DART AEROSPACE LTD		Work Order: 77310
Description: Crosstube Assembly (205/212/412 High Fwd)		Part Number: D212-664-141
Inspection Dwg: D212-664-141 Rev: D		Page 1 of 1

DRAWING NO. D212-664-141	TITLE XTUBE ASSY (205/212/412 HI FWD)	REV. D	DART AEROSPACE LTD ENGINEERING ORDER		D.E.O. NO. D212-664-141-D-1	SHEET NO. SHEET 1 OF 2	SCALE NTS
DRAWN	CHECKED	MFG. APPR.	APPROVED	DE APPR.			
DATE 11.04.07	DATE 11.07.11	DATE 11.04.12	DATE 11/04/12	DATE 11.04.12

ADD AN INSPECTION WINDOW TO UNDERSIDE OF CROSSTUBE.

DRAWING NO. D212-664-141	TITLE CROSSTUBE ASS'Y (205 HI FWD)	REV. D	DART AEROSPACE LTD ENGINEERING ORDER		D.E.O. NO. D212-664-141-D-2	SHEET NO. SHEET 1 OF 1	SCALE NTS
DRAWN <i>UP</i>	CHECKED <i>ASS</i>	MFG. APPR. <i>AS</i>	APPROVED <i>MD</i>	DE APPR. <i>MD</i>			
DATE 11.07.15	DATE 11.07.20	DATE 11.07.21	DATE 11/07/21	DATE 11.07.21

**D212-664-141/-141B
ASSEMBLY DETAIL**

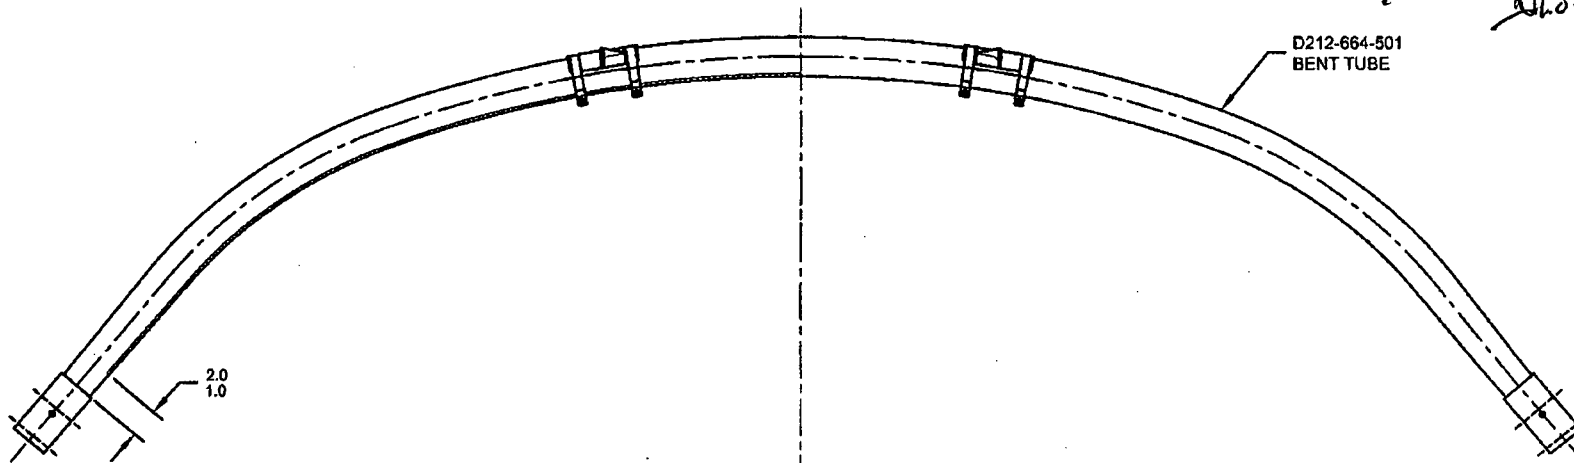
- 2) FINISH: CHEMICAL CONVERSION COAT PER DART QSI 005 4.1
PRIME INSIDE AND OUTSIDE PER DART QSI 005 4.2
MASK UNDERSIDE OF CROSSTUBE AS SHOWN (HATCHED AREA) AND
PAINT OUTSIDE PER DART QSI 005 4.2
REMOVE MASKING AND APPLY CLEAR COAT

- 2) FINISH: CHEMICAL CONVERSION COAT PER DART QSI 005 4.1
PRIME INSIDE AND OUTSIDE PER DART QSI 005 4.2
PAINT OUTSIDE PER DART QSI 005 4.2

MASK AREA PRIOR TO PAINTING,
REMOVE MASKING AFTER PAINT
AND APPLY CLEAR COAT
